Subject: River Bend Station  
Docket No. 50-458  
License No. NPF-47  
Additional Information Related to License Amendment  
License Amendment Request (LAR) 99-15, Changes to Technical Specifications  
for Power Uprate of River Bend Station

Response to NRC Questions Related to River Bend Station Power Uprate Amendment

**Enclosure 2**  
**Response to NRC Questions Related to River Bend Station Power Uprate Amendment**  
**(TAC NO.MA6185)**

Figure D-5 DBA-LOCA Long-Term Drywell and Containment Airspace Pressure.  
RCLB 102% Up-rated Power/ 100% Rated Core Flow, (SHEX-04V)

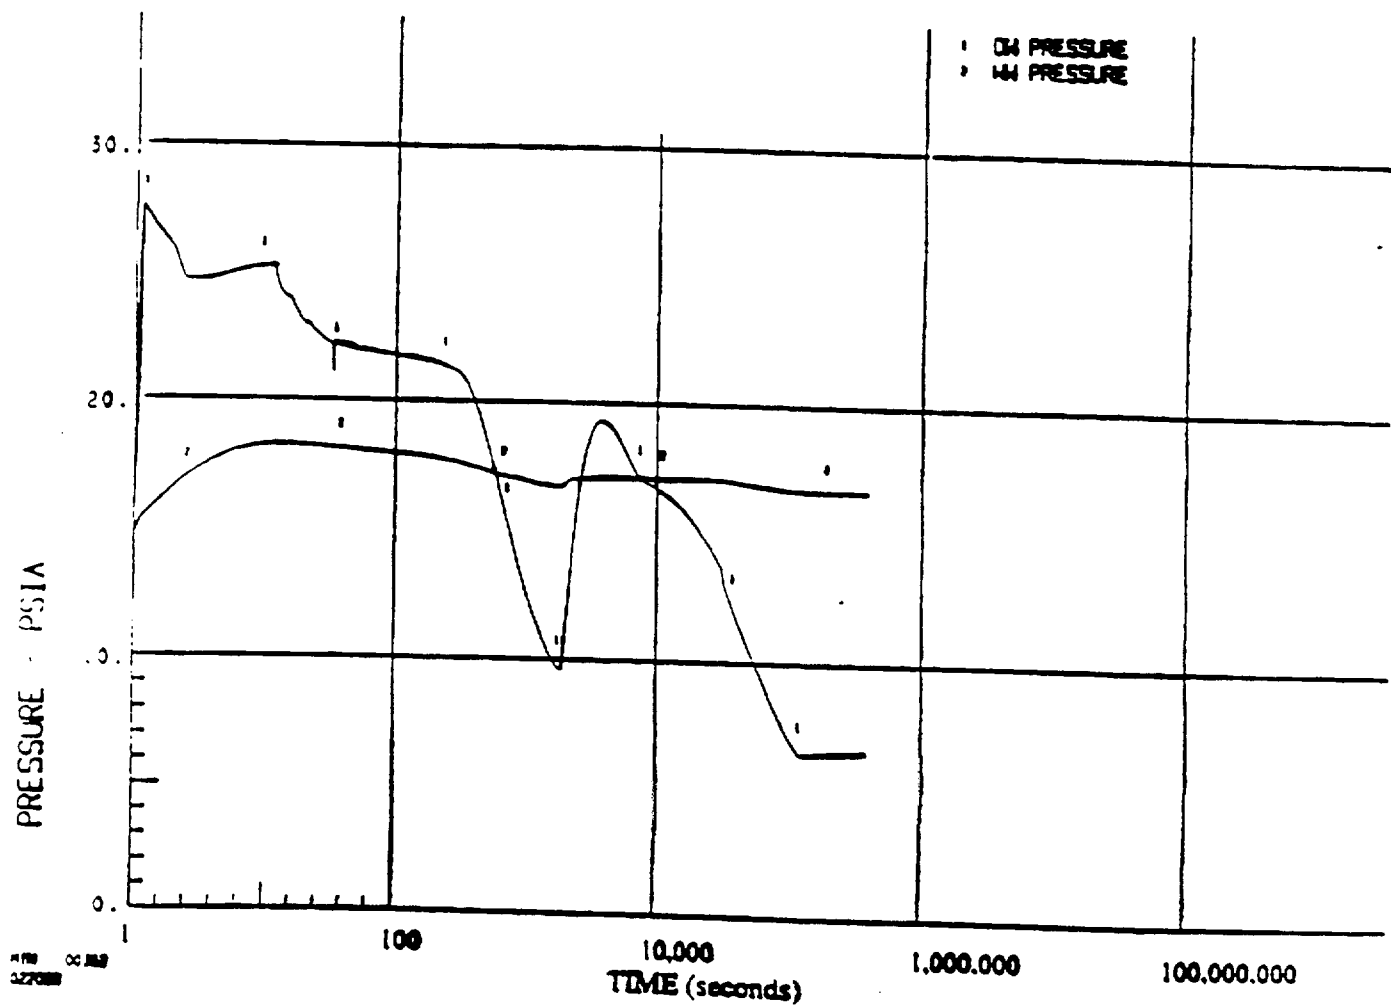
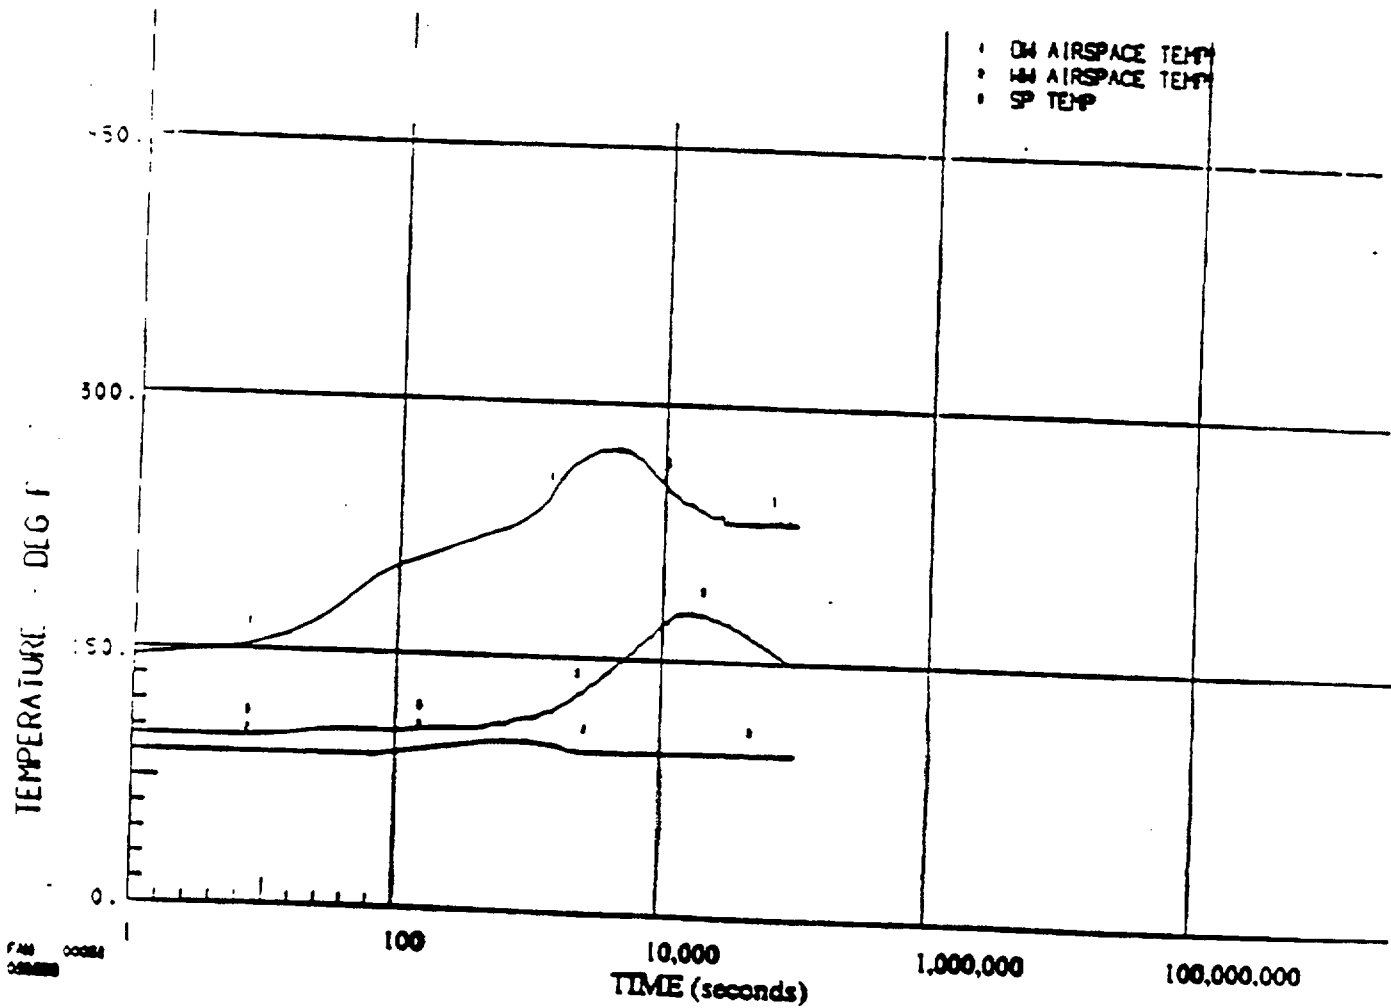
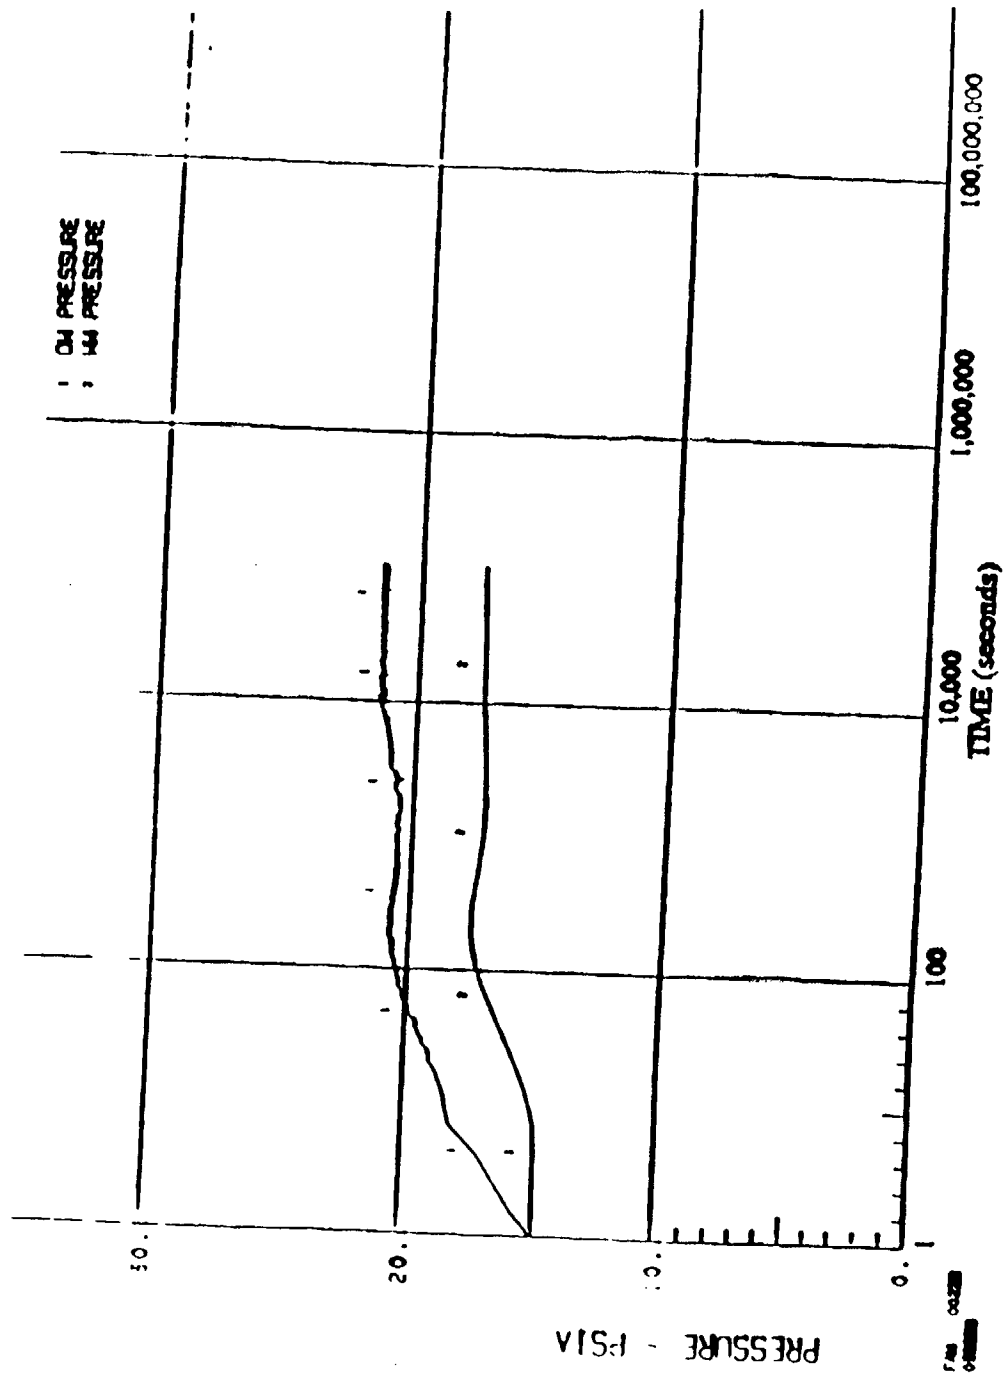
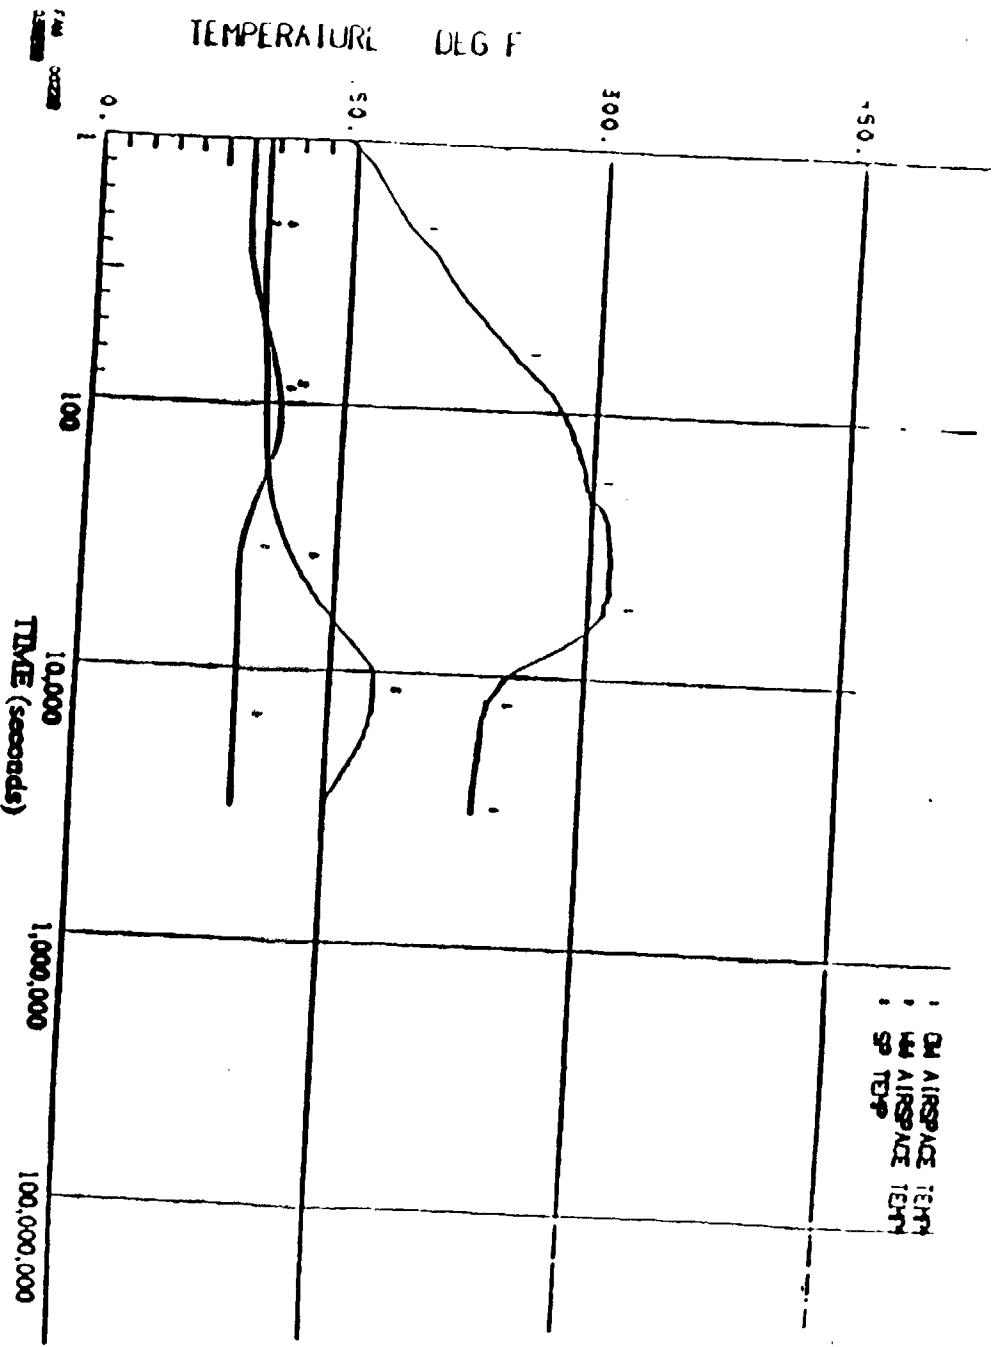
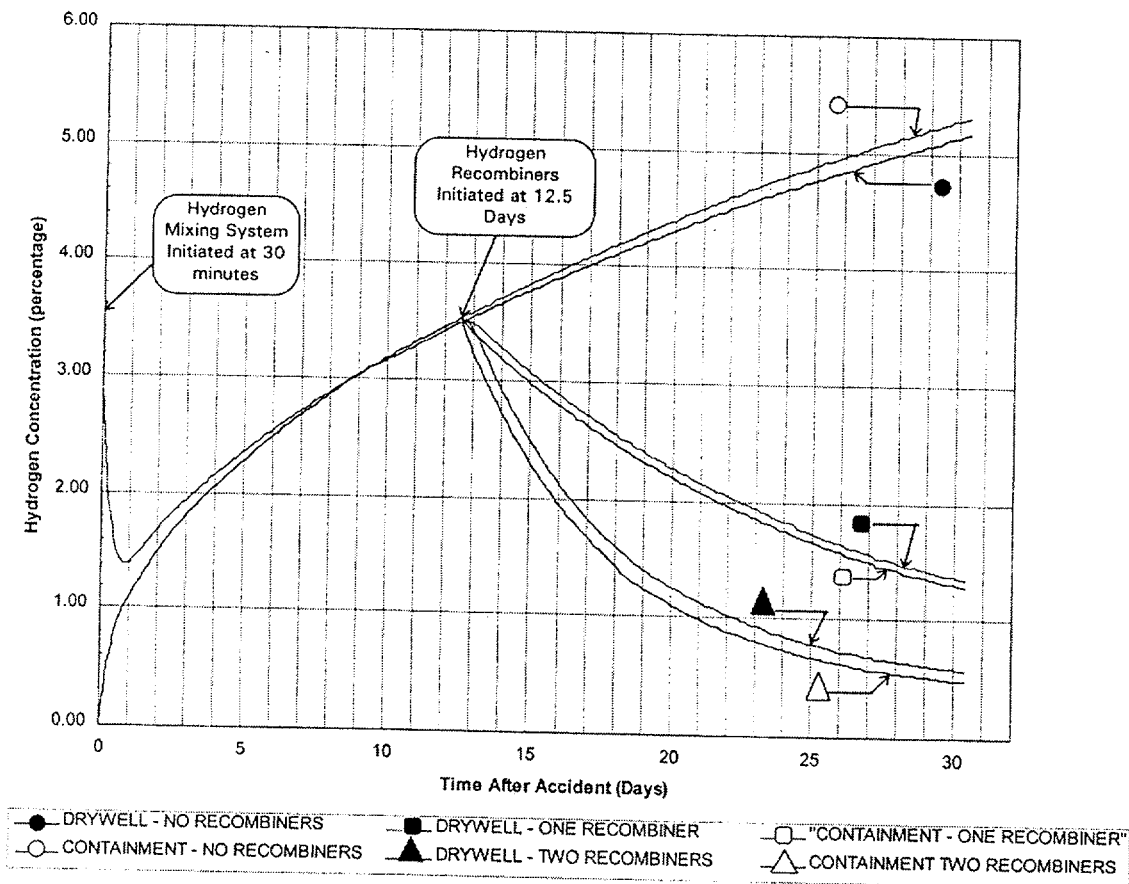
**Question 5:** Please provide the containment analyses maximum pressure and temperature curves at uprated power after a LOCA. Discuss the limiting initial conditions assumed for the DBA LOCA and for the sensitivity case for the MSLB for peak drywell pressure as indicated in Section 4 1.1.3. Also provide the containment drywell pressure limit in psig.

**Response 5:** Drywell & Containment Pressure Temperature Plots are attached at the end of this response. Please note that these figures are considered GE proprietary information. The original USAR analysis was based upon a nominal set of initial conditions. These results were supplemented by a sensitivity analysis to establish the range of acceptable conditions for the containment (Technical Specifications 3.6.1.4, 3.6.1.5, 3.6.2.1, 3.6.5.4, and 3.6.5.5). The following table summarizes the initial conditions, and key results for the nominal case, and significant sensitivities.

*In the table above, the peak drywell temperature is shown to exceed the design limit by approximately 3 °F. This is discussed in Section 4.1.1.3 of NEDC-32778P. The computer program used to calculate the short term response does not include the impact of heat sinks on the temperature rise. If heat sinks are considered, the peak drywell temperature will not exceed 330 °F.*

*The current value of  $P_a$  used for containment testing is 7.6 psig, and is based upon the containment response assuming Technical Specification initial conditions. This value of  $P_a$  bounds the peak containment pressure calculated for uprate. Therefore, the value of  $P_a$  for containment testing will remain 7.6 psig.*
